| DOCKETED         |  |
|------------------|--|
| Project Title:   | Black Rock Geothermal Project (BRGP)   |
| Document Title:  | Staff Response to Committee Orders   |
| Description:     | Staff Response to Request for Information Regarding Cultural and Tribal Cultural Resources |

Staff's Response to: REQUEST FOR INFORMATION REGARDING CULTURAL AND TRIBAL CULTURAL RESOURCES

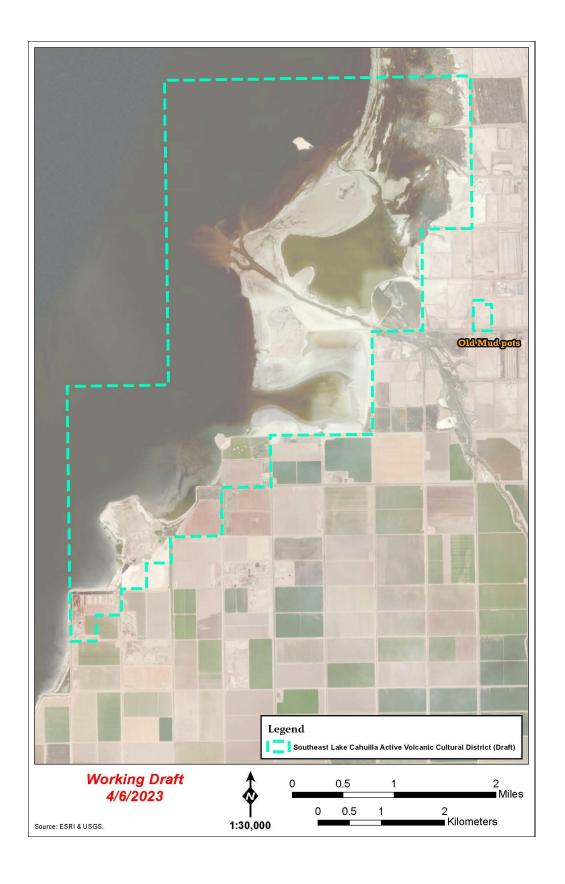
Analysis of the evidence supporting the boundaries of the Cultural District as currently proposed. Nothing herein is directing the filing or public disclosure of confidential information. Confidential information may be discussed in general terms as appropriate. Additionally, to the extent necessary to support the proposed boundaries, Staff shall, and the other Parties may to the extent known to them, cite material filed in the dockets of the proceedings designated as confidential without publicly disclosing the information.

Again, the full evaluation and expression of the results of staff's analysis is appropriately included in the FSA, and these preliminary remarks are subject to change. Based on current data, the Cultural District consists of two discontiguous units (Figure 5.4-2), units A and B. The former contains the five volcanic domes of Obsidian Butte, Rock Hill, Red Island, and Mullet Island; two areas of Mud Volcanoes and Mud Pots (CA-IMP-003256H and The New Mud Pots and Volcanoes); a Pond of Good Water (CA-IMP-3251H); and the Saltwater Pond (CA-IMP-003255). Unit B contains the Mud Volcanoes and Old Mud Pots (CA-IMP-003257H). (TN 257697, page 5.4-50; see figure below.)

The Cultural District incorporates the main cultural features of the Salton Buttes: Obsidian Butte, Rock Hill, Red Hill, Mullet Island, the sets of mud pots, as well as their physical and visual connectivity, and setting. The boundary shape is drawn from information presented to CEC cultural staff by tribal representatives during the consultation process. The Cultural District boundary roughly follows the Salton Sea Shallow Geothermal Anomaly, although it is depicted with a smaller footprint. Because the water line for the Salton Sea is not static, the delineation of boundary lines mostly corresponds with United States Geological Survey guadrangle map section and section subdivision lines, which is consistent with the Native American Heritage Commission practices for Sacred Lands File searches. The Salton Sea contributes to the district by creating a visual setting resembling Lake Cahuilla in pre-contact times. Future identification of additional contributing and character defining features and buffers from potential incompatible uses, as defined by the perspective of the living traditional community (local tribes), may result in adjustment of boundaries in the future. Given the dynamic nature of this landscape, boundaries also consider fluctuations in the water line of the sea. (TN 257697, page 5.4-53.)
